EASTSIDE PUMP STATION REPLACEMENT OF PUMPS 1 AND 2

CITY OF ROCKWALL, TEXAS
EASTSIDE PUMP STATION
REPLACEMENT OF PUMP NOS. 1 AND 2

ADDENDUM NO. 1
April 13, 1999

CITY OF ROCKWALL, TEXAS
EASTSIDE PUMP STATION
REPLACEMENT OF PUMP NOS. 1 AND 2
CHANGE ORDER NO. 1

SCHEMATIC - C-H 125 H.P. SOFT STARTERS
TYPICAL FOR P-1, P-2 & P-4 (ALTERNATE)

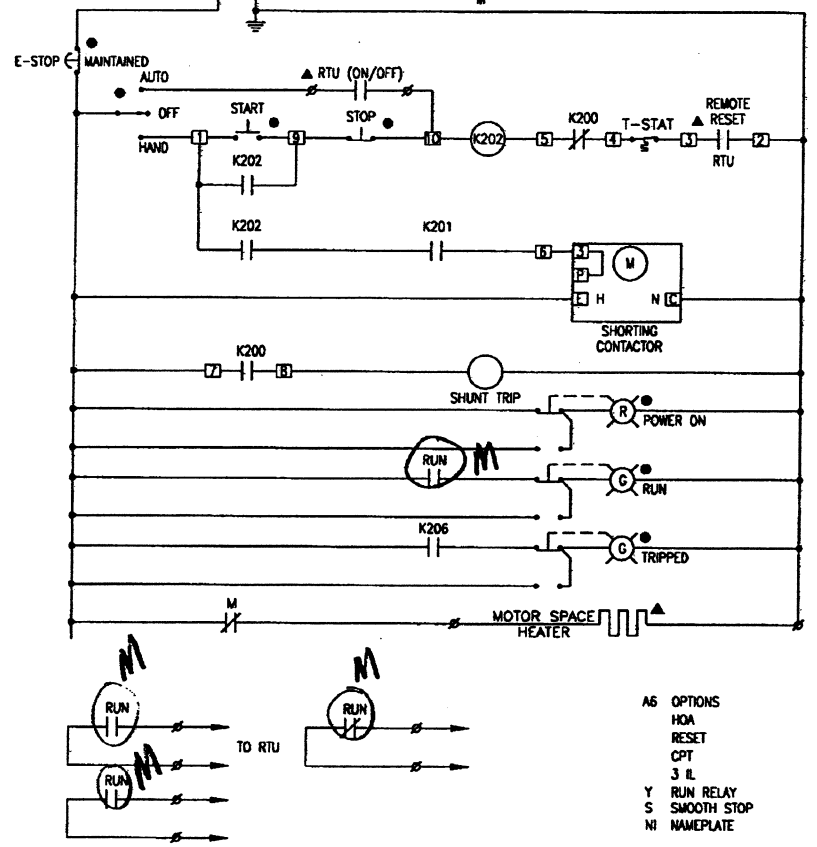
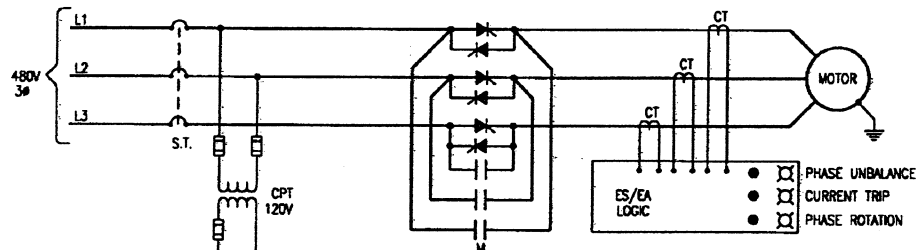
- Refer to Drawing E4, Sheet 10 - Schematic C-H 125 Soft Starters. Change contact labeled "RUN" to "M".
 - Refer to Drawing E5, Sheet 11.
 - Detail 01, Note 2. Change #1/0 EGC to #4/0 EGC. Delete Note 3.

01 ELEVATION OF STANDBY GENERATOR
NOT TO SCALE

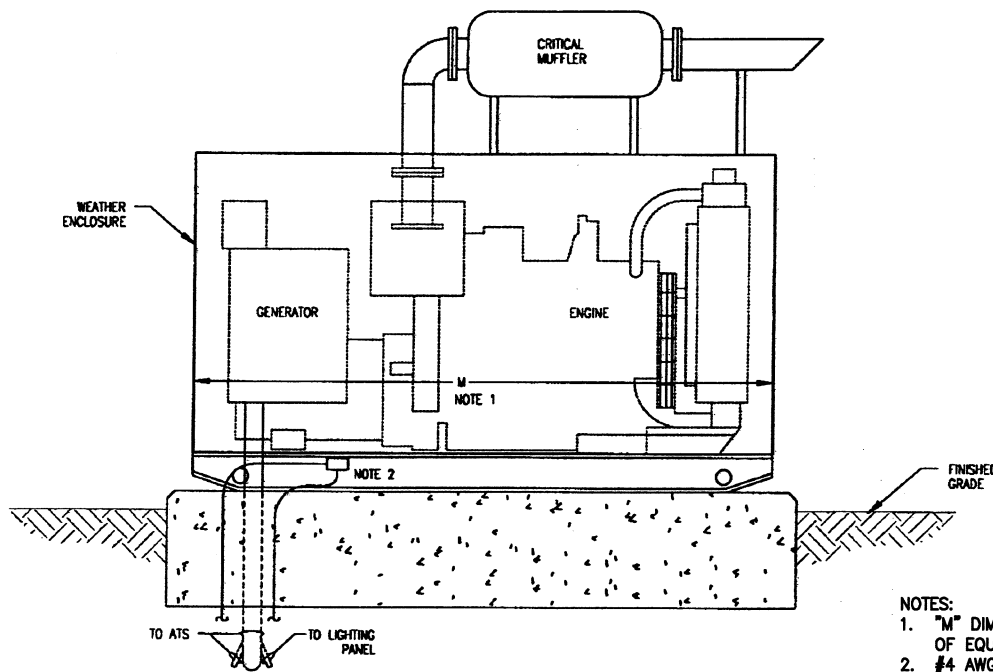
- Add the following Notes:
Note 4: Width and Length of Slab will be "M" + 12" on each side. Slab shall be 24" thick.
Note 5: 3000 PSI Concrete Pad, Reinforced with #6 Rebars @ 12" O.C.B.W. Top and Bottom. 1" Chamfer all around Top. Exposed Concrete Surfaces shall be rubbed smooth. Compact Soil under Pad to Proctor 90.

ELEVATION - PUMP No.1
NOT TO SCALE

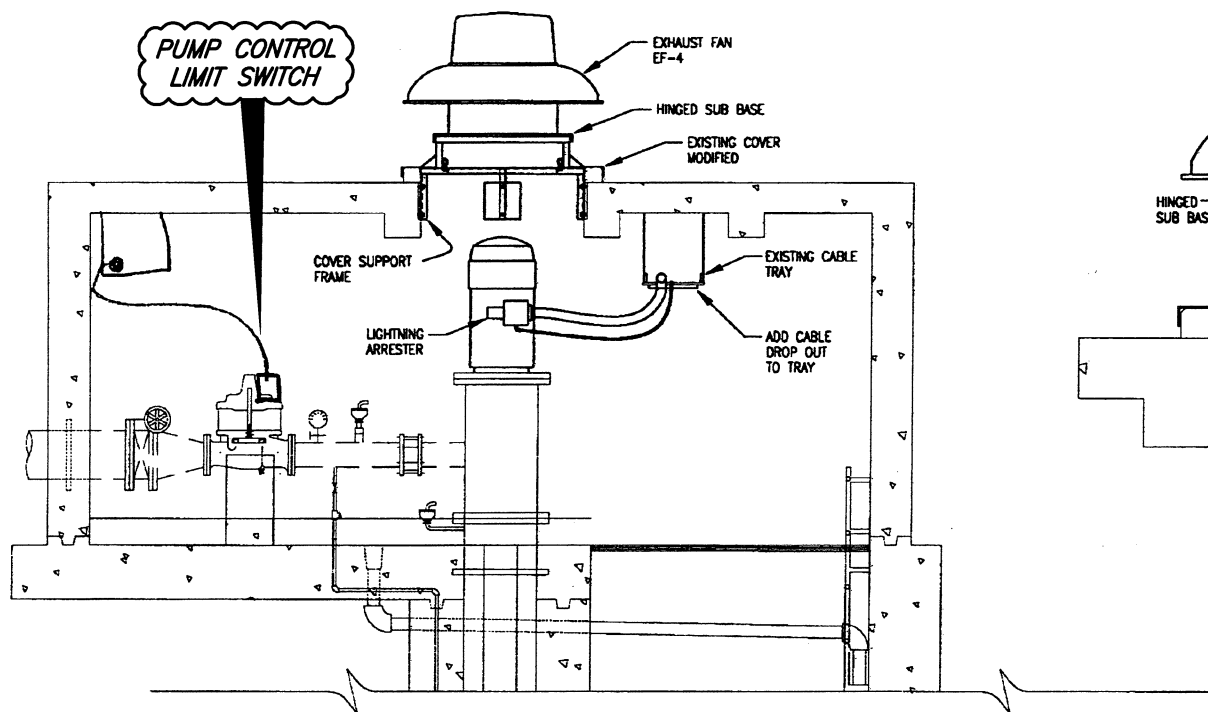
- Refer to Drawing E6, Sheet 12.
 - Show Pump Control Check Valve Limit Switch on Elevation Pump No. 1.
 - RTU Schedule: Change to RTU I/O Schedule.
 - ZS-P1, P2 and P4 Field Device: Change "Dump" to "Pump".
 - P1 ON: Add a Discrete Input
 - Add four Permissive Start "Discrete Inputs" from the Automatic Transfer Switch. This tells the RTU that the load has transferred and then allows sequential re-start to the active pump motors. Four motors may run on utility power but only three are allowed on Generator Power.
 - Bidders shall acknowledge receipt of Addendum No. 1 in the space provided in the Proposal, on the outer envelope of their bid, and by faxing back the "Transmittal of Addendum Acknowledgment Sheet" to Shimek, Jacobs & Finklea, L.L.P. at (214) 361-0204.
- SHIMEK, JACOBS & FINKLEA, L.L.P.
CONSULTING ENGINEERS
DALLAS, TEXAS
